CITY OF TONTITOWN PLANNING OFFICE

Meeting: **March 26, 2019**
Project: **Patriot Metals**
Planner: Courtney McNair

ii. PRELIMINARY LARGE SCALE DEVELOPMENT PLAN APPROVAL

iii. WAIVER -ARCHITECTURAL FACADE

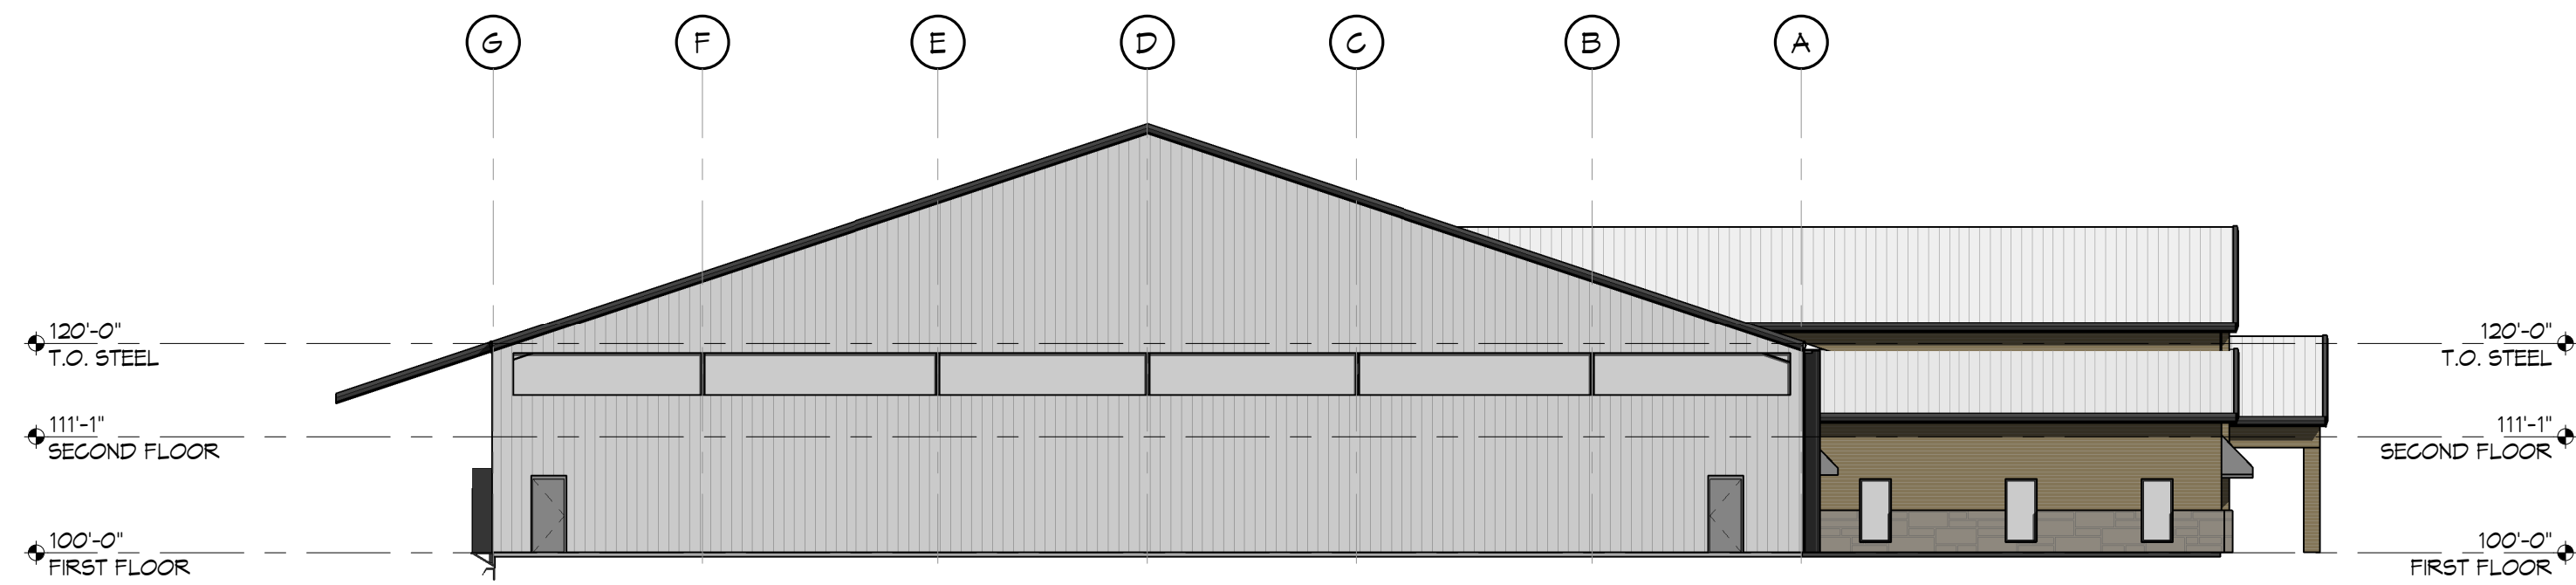
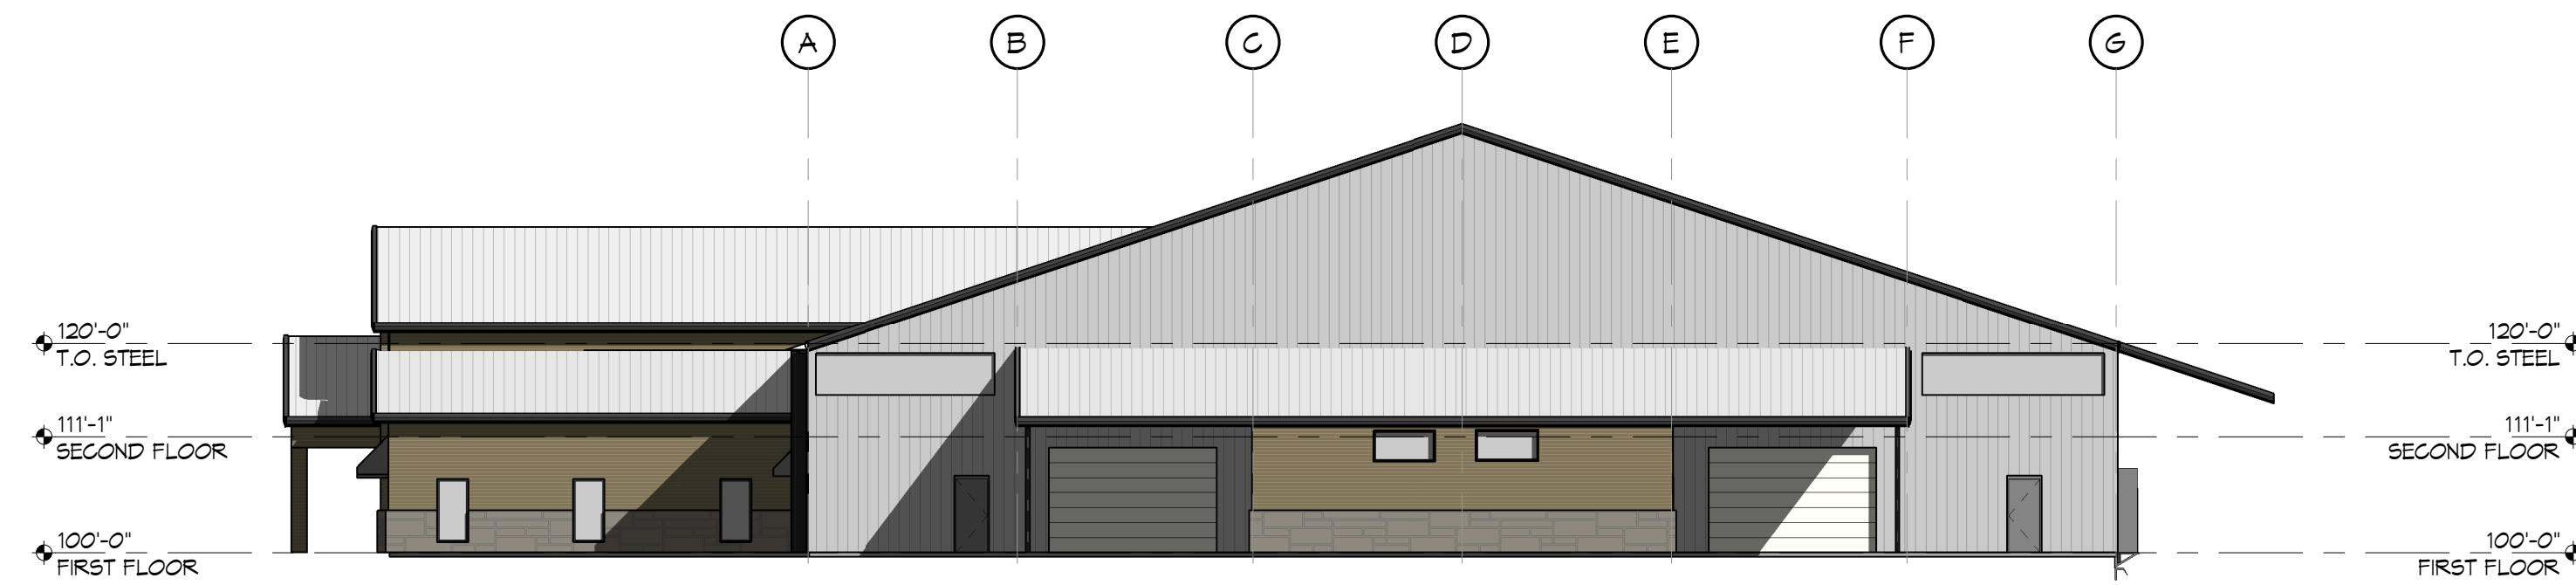
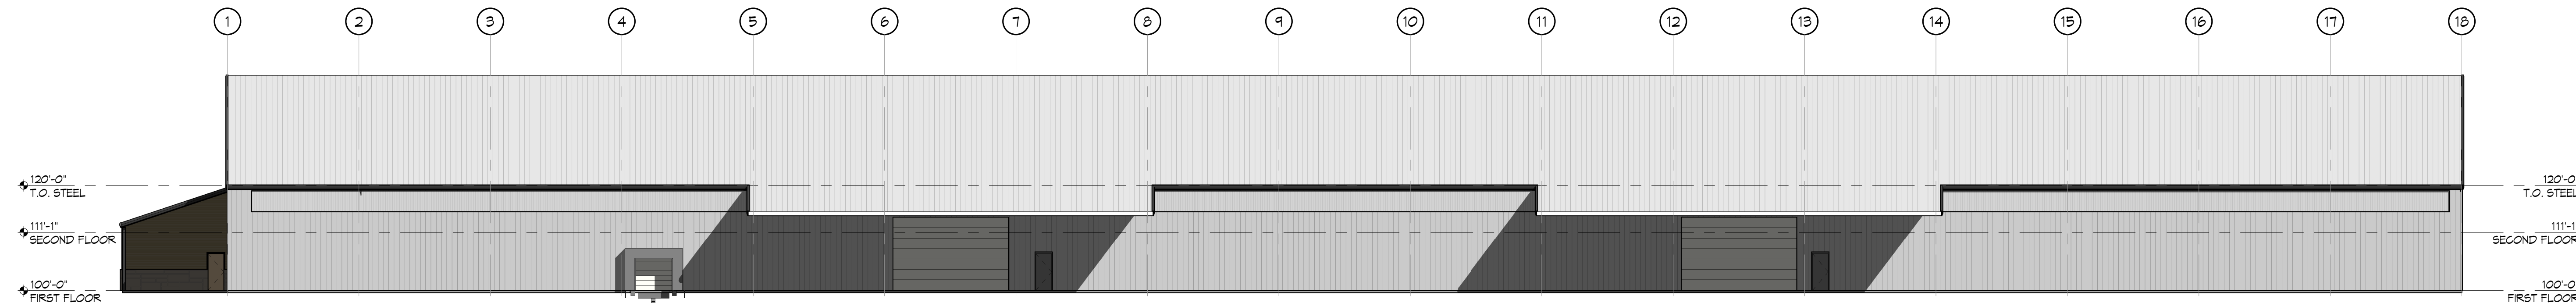
Architectural plans were submitted. The plans submitted do not meet the 75% masonry requirement, and they do not meet the roof line articulation requirement

Architectural plans were submitted. The plans submitted do not meet the 75% masonry requirement, and they do not meet the roof line variation or wall articulation requirement.

STAFF RECOMMENDATION: Staff recommends approval of the waiver allowing less than 75% masonry façade, not requiring the roof to have height changes every 100 linear feet, and not requiring the façade have articulation every 100 linear feet.

1. This building must generally develop as proposed.
2. If the roof type is changed from a gable, or the front entrance façade reduced, the applicant shall be required to seek an additional waiver from this Board.
